Model: Stinger – C1		Date: 15-Oct-99	No.: MA250001
Modified Article: Weak Vertical Transport		Prepared by: K. Miura	
From: Technical Service Dept., GTS Division			
Reason for Modification:	☐ Parts catalog correction ☐ To facilitate assembly ☐ Part standardization	☐ Vendor change ☒ To improve reliability ☐ Other	☐ To meet standards ()

Model: Stinger – C1

No.: MA250001

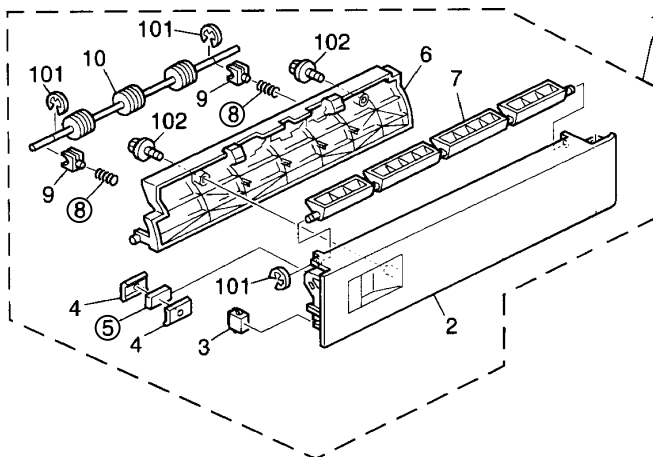
To improve vertical transport, the spring and magnet will be modified.

Old part number	New part number	Description	Q'ty	Int	Page	Index	Note
A2502772	A2502780	Spring	2	X/O	29	8	
AG070012	A2502783	Magnet	1	X/O	29	5

No.: MA250003

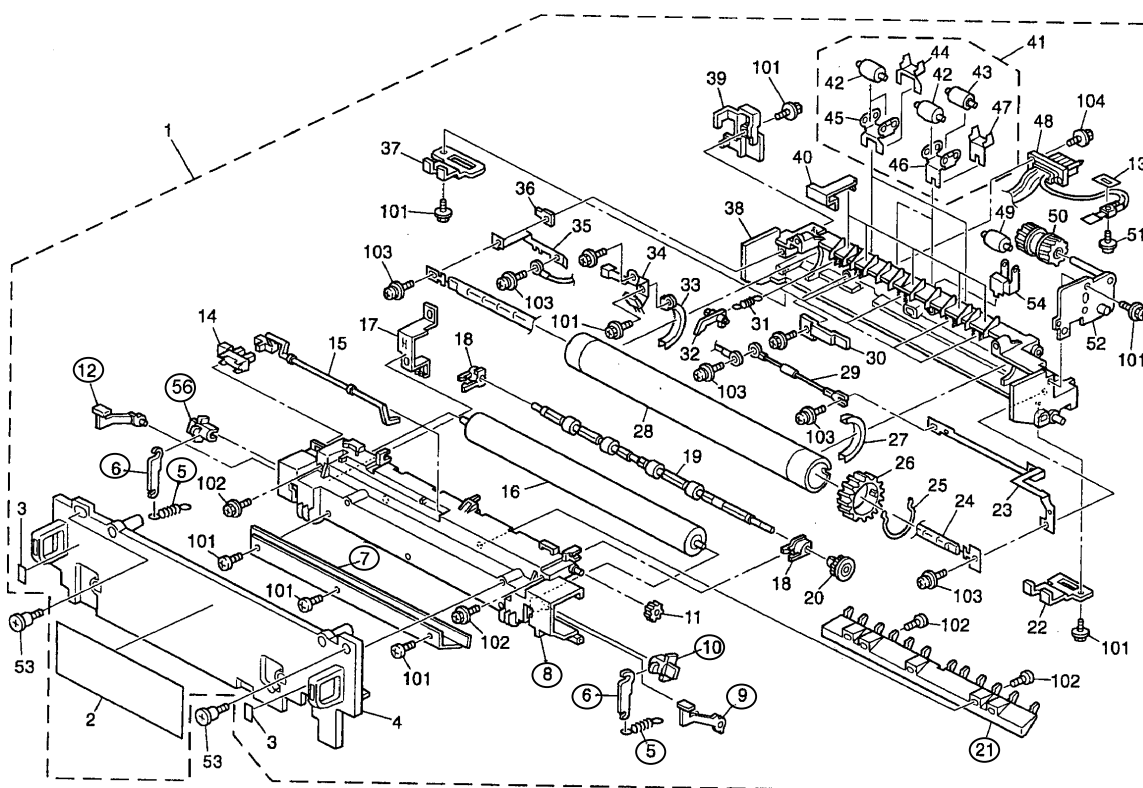
To prevent this, the position of the pressure roller has been changed so that the paper enters the fusing unit at a gentler angle (5 degrees, changed from 20 degrees).

Old part number	New part number	Description	Q'ty	Int	Page	Index	Note
G0294106	A2504105	Pressure Roller Case	1	X/X	21	8	
G0294064	A2504064	Fusing Entrance Guide	1	X/X	21	7	
G0294116	A2504116	Ground Plate	1	X/X	21	17	
G0294135	A2504135	Pressure Roller Lever	2	X/X	21	6	
A2504136	A2504138	Pressure Release Lever – Rear	1	X/X	21	9	
A2504137	A2504139	Pressure Release Lever – Front	1	X/X	21	12	
G0294150	A2504150	Pressure Spring	2	X/X	21	5	
G0294174		Pressure Roller Bushing	2	X/X	21	10	
	A2504177	Pressure Roller Bushing – Front	1	X/X	21	10	
	A2504178	Pressure Roller Bushing – Rear	1	X/X	21	56	
G0294187	A2504187	Exit Guide Plate	1	X/X	21	21

No.: MA250004

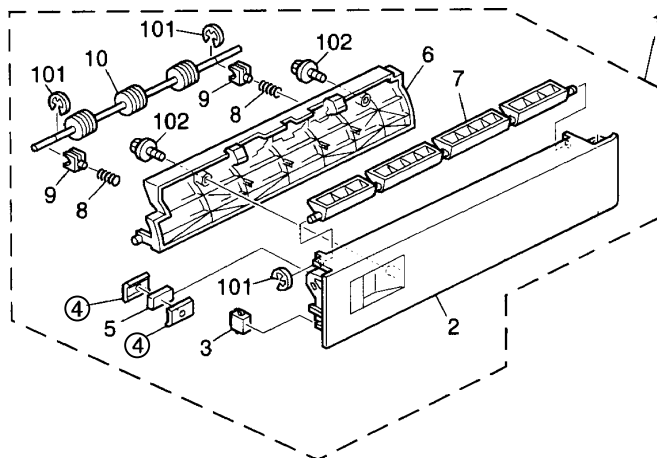
To improve vertical transport, the brackets of the magnet will be modified.

Old part number	New part number	Description	Q'ty	Int	Page	Index	Note
G6971261	A2502782	Bracket: Magnet	2	X/O	29	4

No.: MA250005

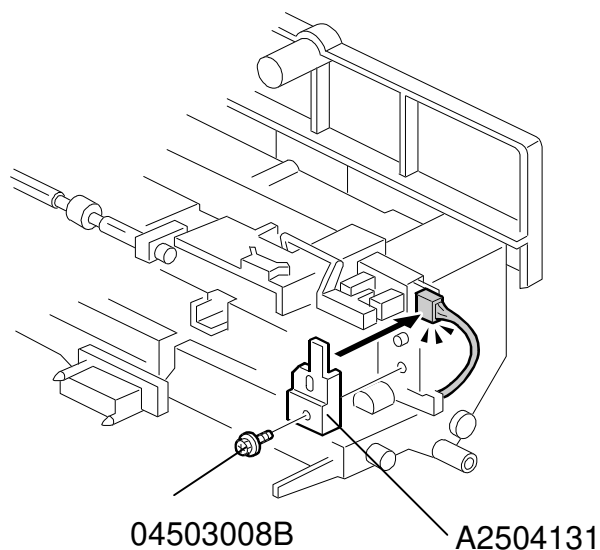
To prevent the exit sensor from disconnecting, the following parts were added.

Old part number	New part number	Description	Q'ty	Int	Page	Index	Note
	A2504131	Plate – Exit Sensor	1		21	55	
	04503008B	Tapping Screw – M3x8	1		21	101

Model: Stinger-C1	Date: 15-Nov-99	No.: MA250007
-------------------	-----------------	---------------

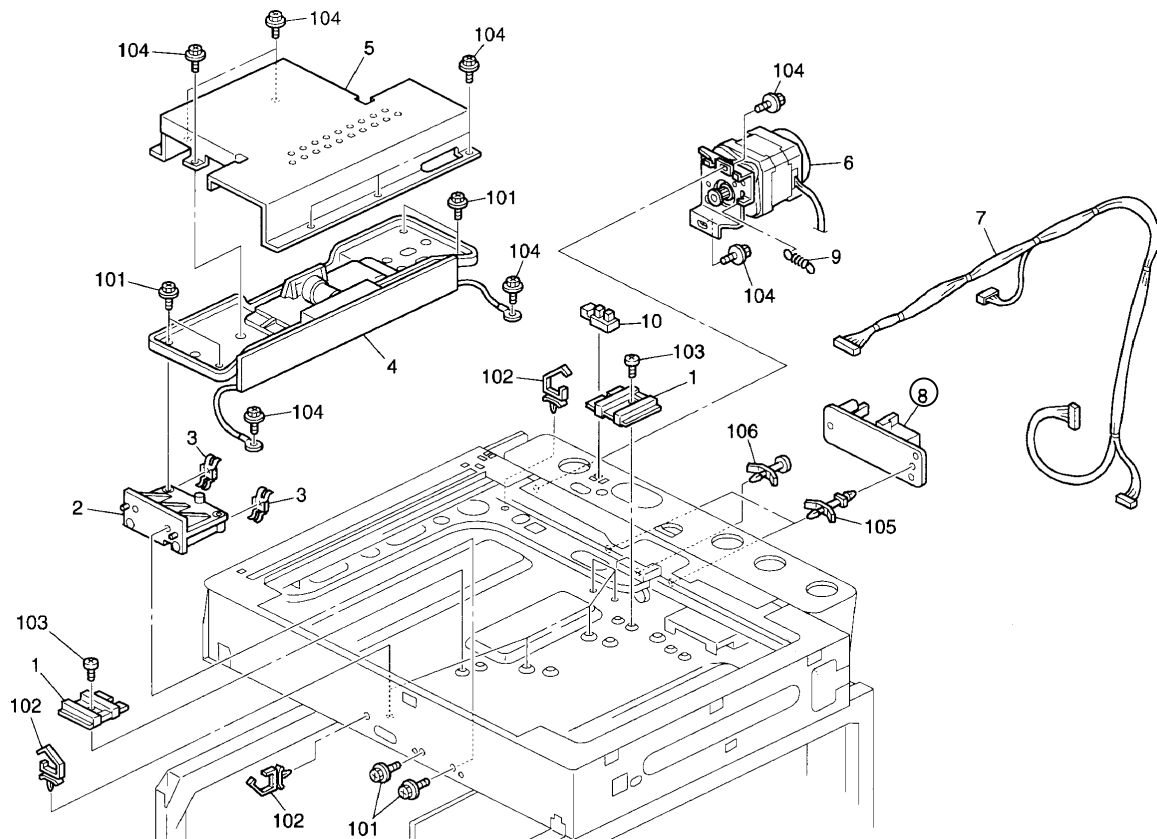
In response to comments from the production division that the lamp stabilizers were difficult to install during machine assembly, the stabilizer has been reduced in size.

Old part number	New part number	Description	Q'ty	Int	Page	Index	Note
A2505735	A2505736	Lamp Stabilizer	1	O/O	13	8

No.: MA250008

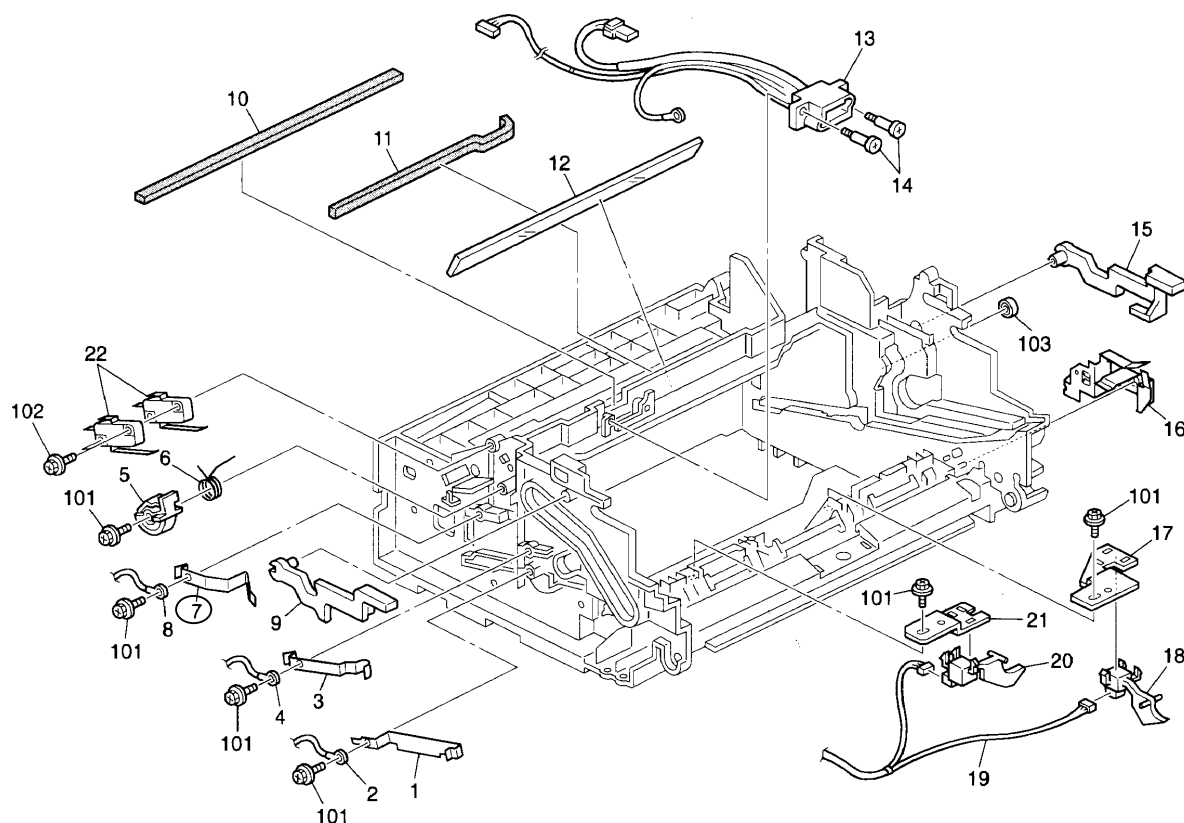
In response to a report of a poor grounding plate connection, the shape of the plate has been modified.

Old part number	New part number	Description	Q'ty	Int	Page	Index	Note
G0291080	G0291089	Grounding Plate – Charge	1	X/O	25	7

Model: Stinger-C1	Date: 15-Nov-99	No.: MA250009
-------------------	-----------------	---------------

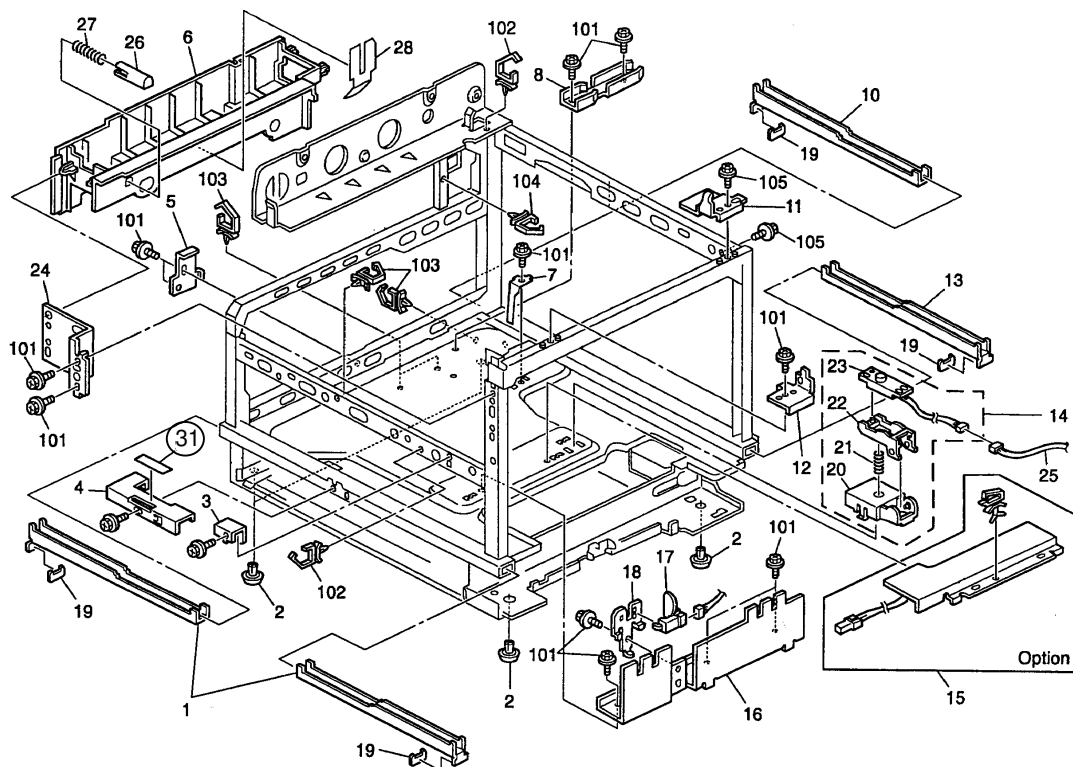
Part of the bottom plate lever tray was hitting the front cover when the tray was closed. A cushioning material has been attached to the front cover to prevent any damage.

Old part number	New part number	Description	Q'ty	Int	Page	Index	Note
	A2501058	Cover Cushion – 5 mm	1		41	31

Model: Stinger-C1	Date: 15-Nov-99	No.: MA250010
-------------------	-----------------	---------------

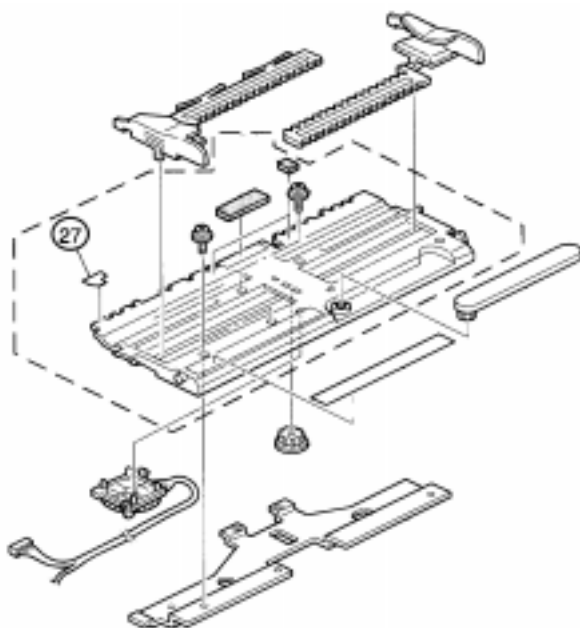
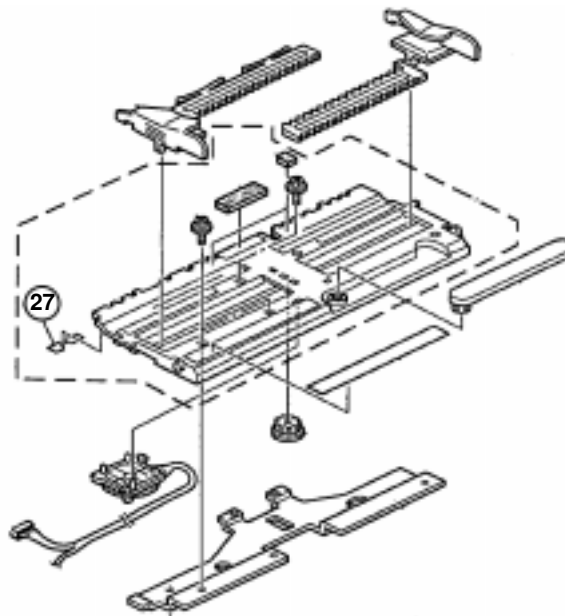
The harness became caught between the mainframe and bypass feed table.
 The shape of the sheet on the bypass feed table has been changed to prevent this.

Old part number	New part number	Description	Q'ty	Int	Page	Index	Note
A2502958	A2502962	Sheet – Bypass Feed Table	1	X/O	29	27

No.: MA250011

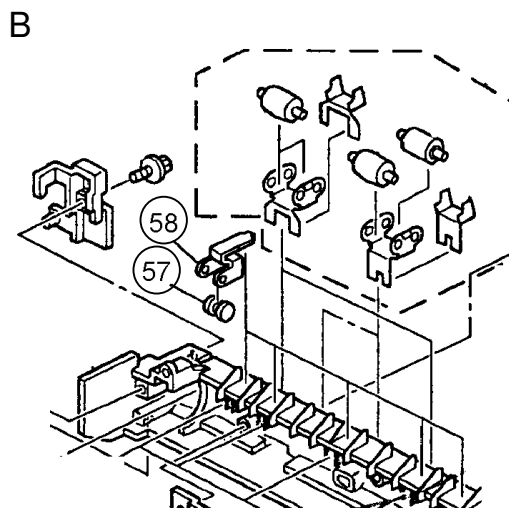
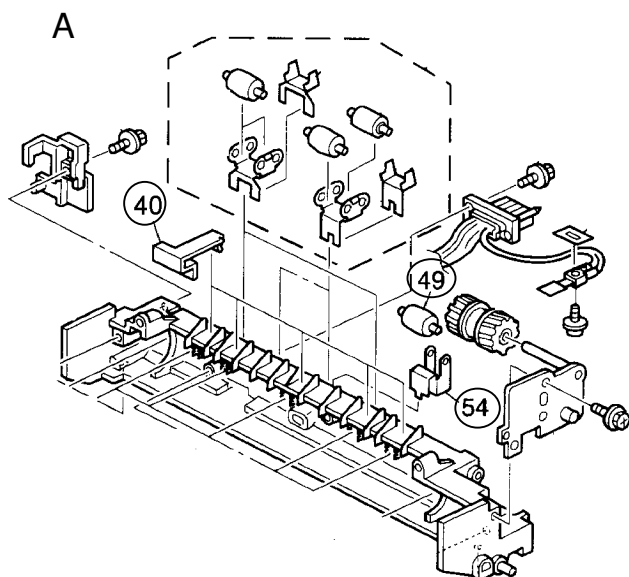
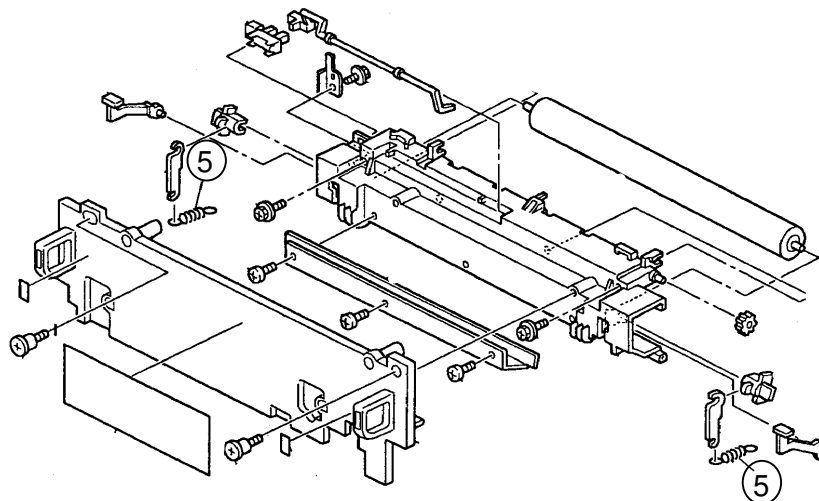
In order to prevent the five stripper pawls from leaving marks on copies, the mechanism has been modified so that the pawls apply pressure uniformly across the copy. In addition, the tension of the pressure roller springs has been increased in order to ensure that copies are properly fed through the heat and pressure rollers.

When there is a problem with any of three components labeled in illustration A (40,54,49), they must all be removed together and replaced with the two components labeled in illustration B (57,58).

Old part number	New part number	Description	Q'ty	Int	Page	Index	Note
G0294151		Stripper Pawl Stopper	5		21	40	A
G0294134		Spring Plate	2		21	54	A
G0294176		Turn Roller – Exit Sub-unit	2		21	49	A
	H3062138	Roller – Stripper Pawls	5		21	57	B
	H3062139	Stopper – Stripper Pawls – 1	5		21	58	B
A2504150	A2504156	Spring – Fusing – Exp	2	X/O	21	5

No.: MA250012

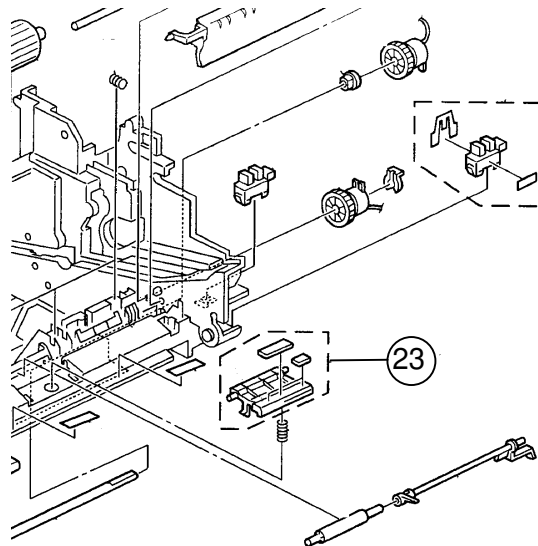
To feed envelopes properly, the following item has been changed.

Old part number	New part number	Description	Q'ty	Int	Page	Index	Note
A2502910	A2502920	Friction Pad – Manual Feed	1	X/O	23	23

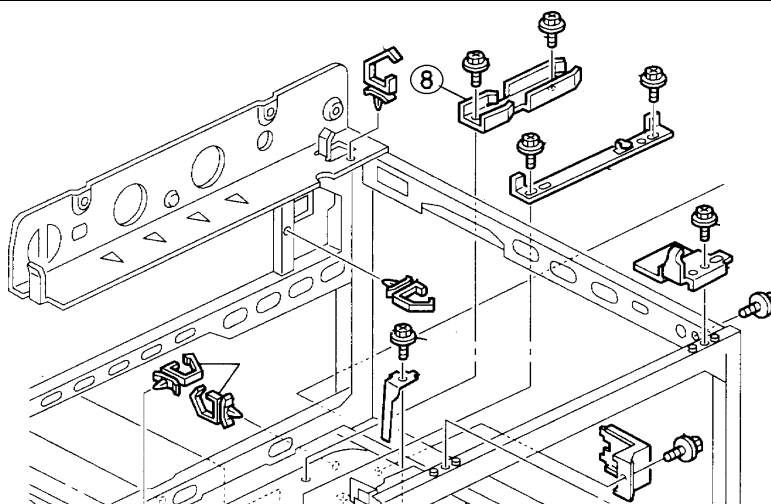
The following part has been changed to reduce noise.

Old part number	New part number	Description	Q'ty	Int	Page	Index	Note
A2501039	A2501050	Lower Holder – Printer	1	X/O	41	8

No.: MA250019

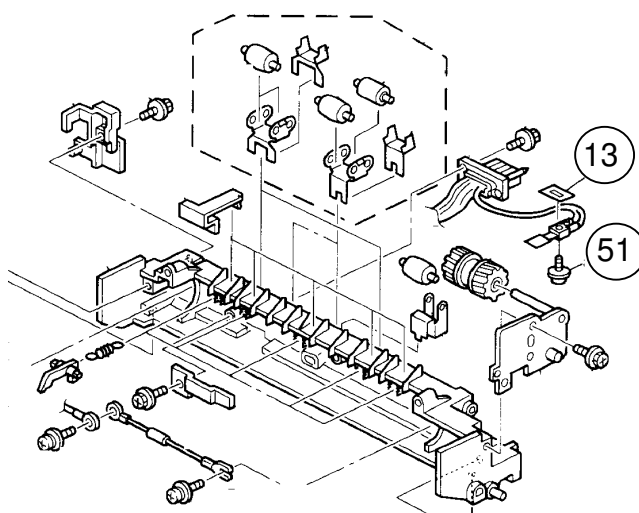
The screw for the thermistor has been modified and given a new P/N. The screw was modified because the screw insert (in the frame) was changed from a molded to a metal type. Due to these modifications, the thermistor shield is no longer necessary and has been deleted.

Old part number	New part number	Description	Q'ty	Int	Page	Index	Note
G0294159	G0294158	Screw – M3x3	1	X/O	21	51	
G0294154		Thermistor Shield	1		21	13

No.: MA250020

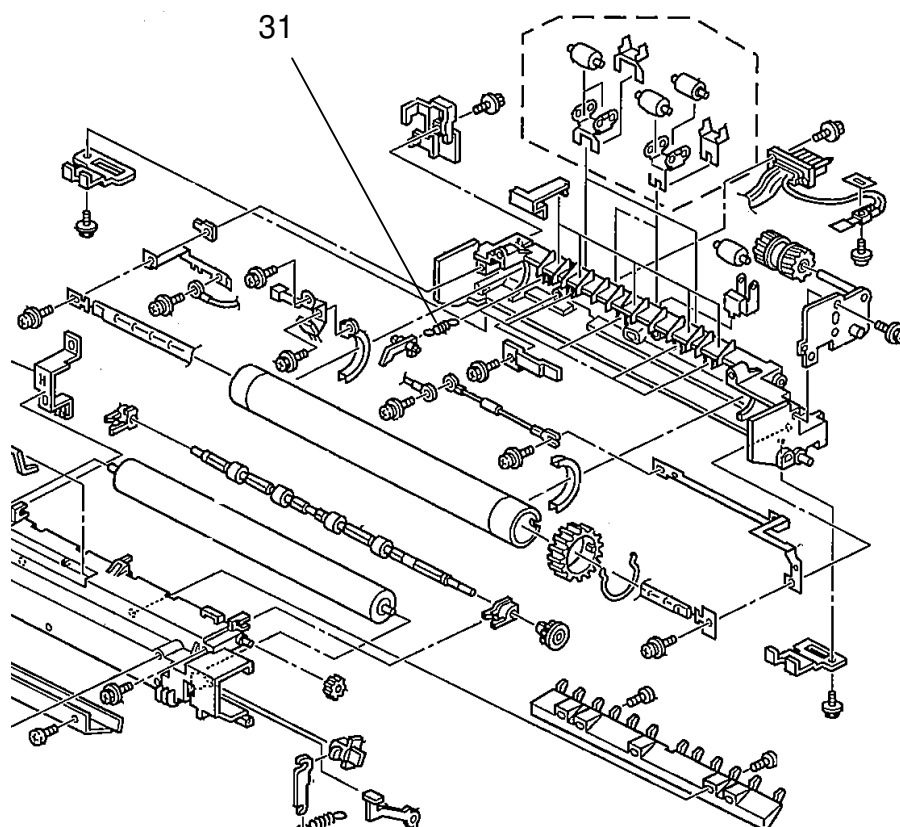
The spring tension has been increased to prevent paper misfeed at the fusing unit.

Old part number	New part number	Description	Q'ty	Int	Page	Index	Note
G0294143	A2504143	Pickoff Pawl Spring	5	X/O	21	31

No.: MA250021

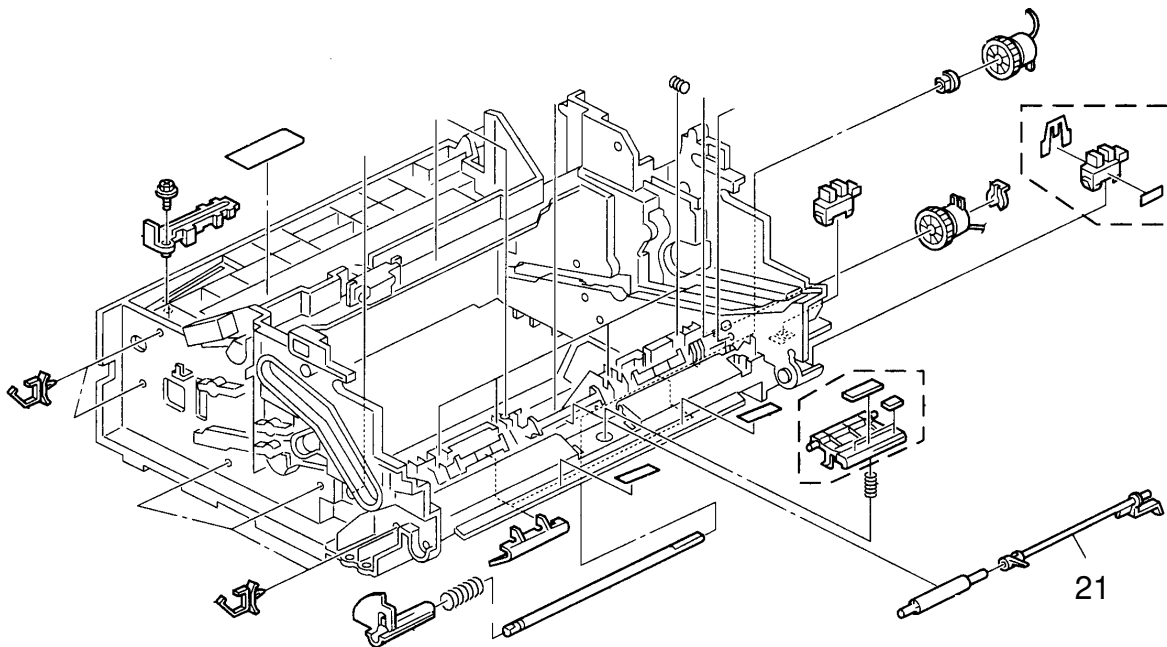
To prevent the registration feeler from disconnecting, the following part has been changed.

Old part number	New part number	Description	Q'ty	Int	Page	Index	Note
G0292556	A2502659	Registration Feeler	1	X/O	23	21

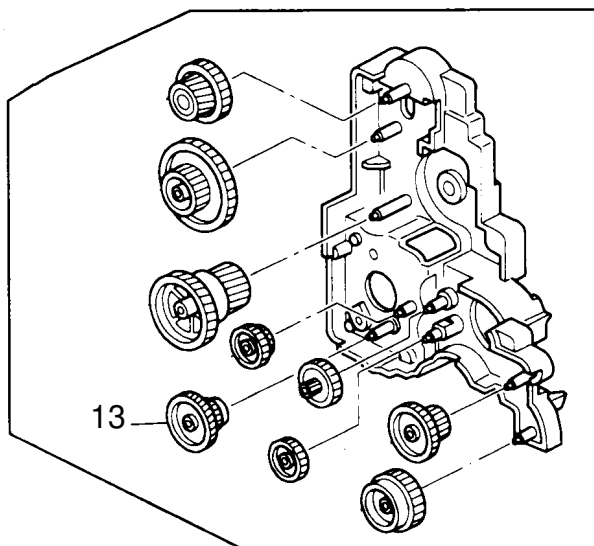
The gear will be modified to prevent abnormal sound.

Old part number	New part number	Description	Q'ty	Int	Page	Index	Note
G0291110	G0291120	Gear: C-6	1	O/O	35	13

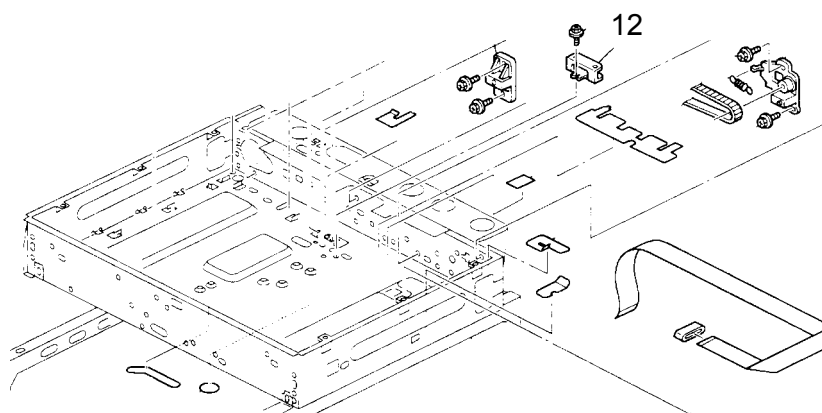
The shape of the positioning bracket has been modified to facilitate assembly.

Old part number	New part number	Description	Q'ty	Int	Page	Index	Note
A2501756	A2501830	Positioning Bracket	1	O/O	17	12
